Sent: 1/05/2019 11:25:56 AM
Subject: RMS Resposne - 973 Pittwater Road Collaroy
Attachments: 20190121 - RMS Response - 973 Pittwater Road, Collaroy.pdf;

Council Reference: DA2018/1981

Description: Alterations and additions to a dwelling house

Address: 973 Pittwater Road COLLAROY

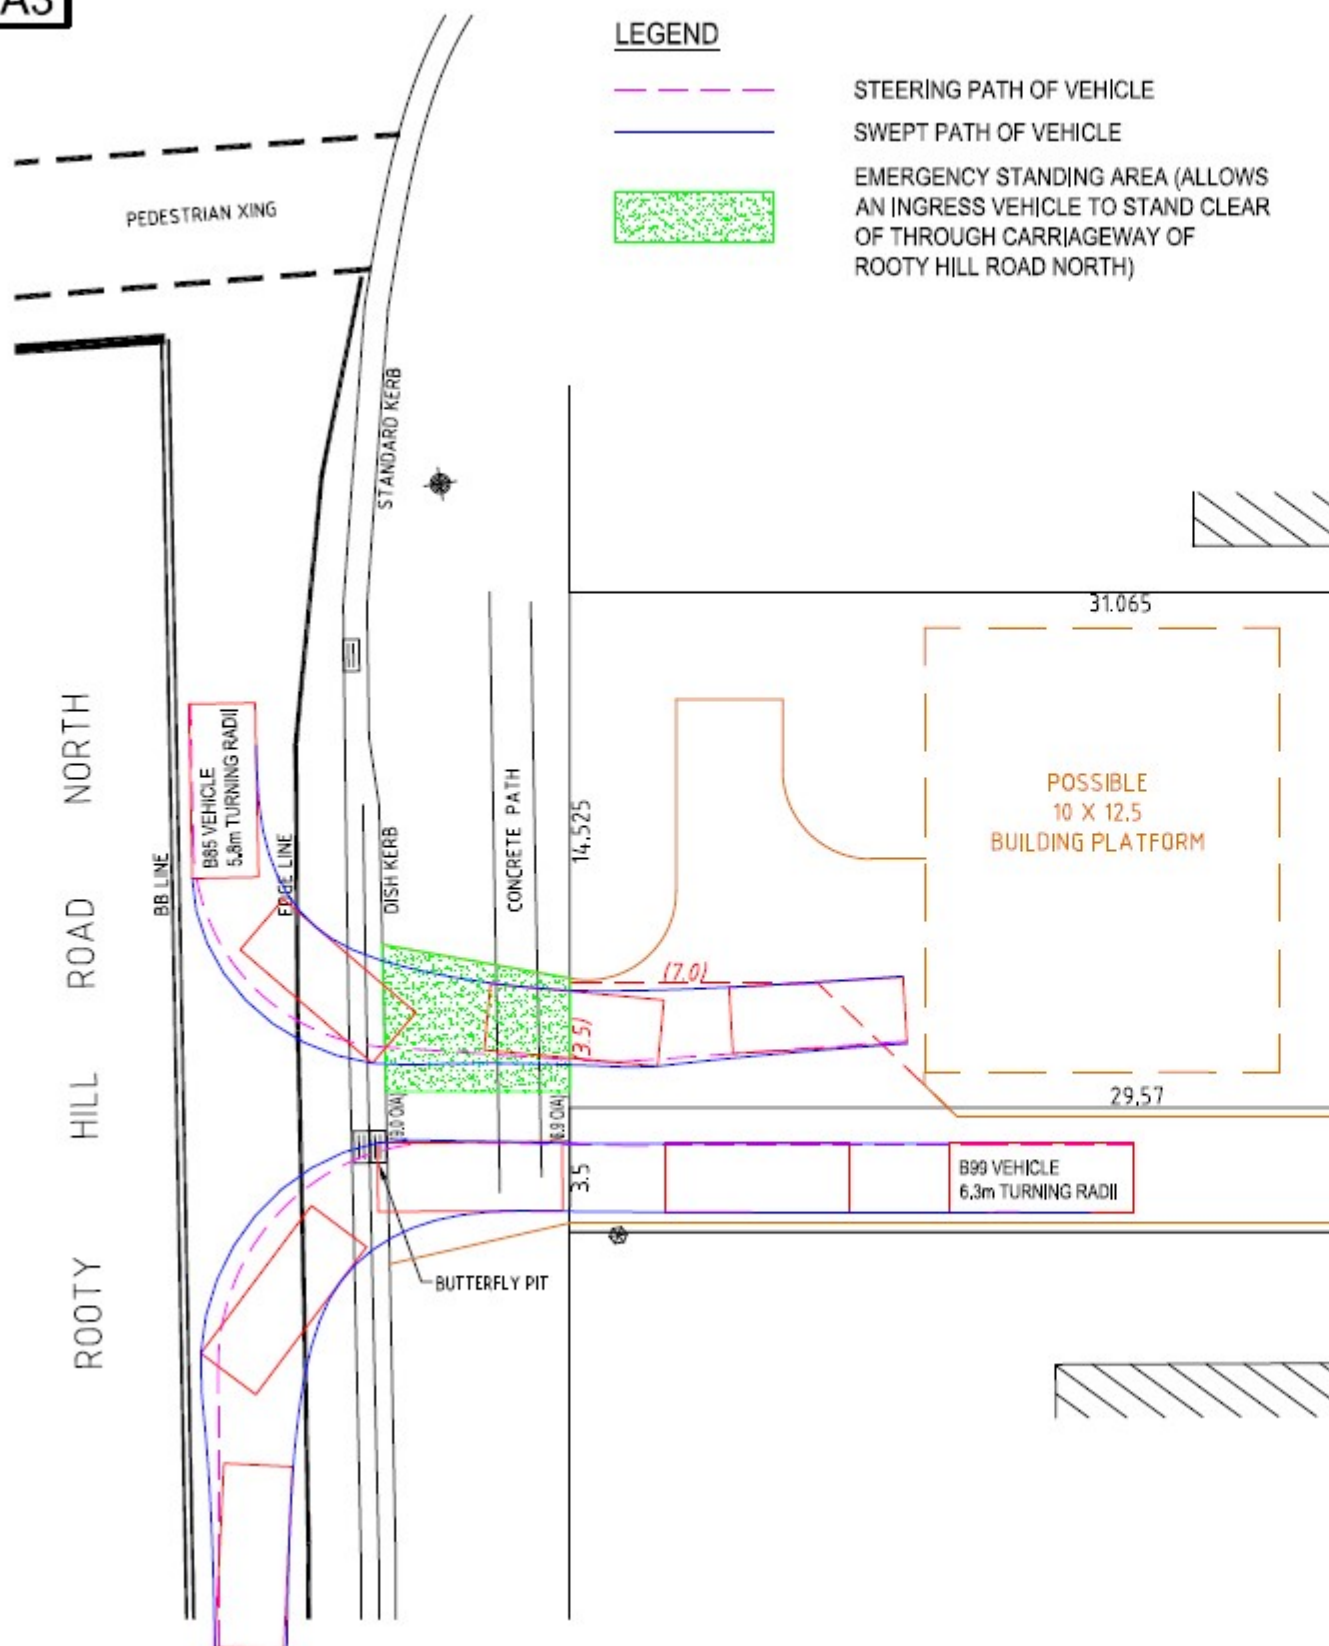
- Swept path plans are to be provided for review showing that two vehicles simultaneously access the site. Roads and Maritime require that future plans clearly depict of how all vehicles will enter and exit the site from Pittwater Road in a forward direction in accordance with Australian Standards.

The swept path plans provided show basic turning movements within the property only. In the original letter Roads and Maritime provided information in relation to how two vehicles simultaneously access the site was requested. Roads and Maritime need to be satisfied that a vehicle can access the site from the kerb side lane and another vehicle can exit the site into the kerb side lane at the same time. The current plans do not address this issue and as such the previous letter, dated 21 January 2019, still applies. Below is a screenshot of a site which has correctly demonstrated simultaneously access arrangements. Please note that this plan contains the civil design details required to assess the access (kerb markings / line markings / driveway notation).

Please have the applicant provide the originally requested information so that the Roads and Maritime assessment can be finalised.
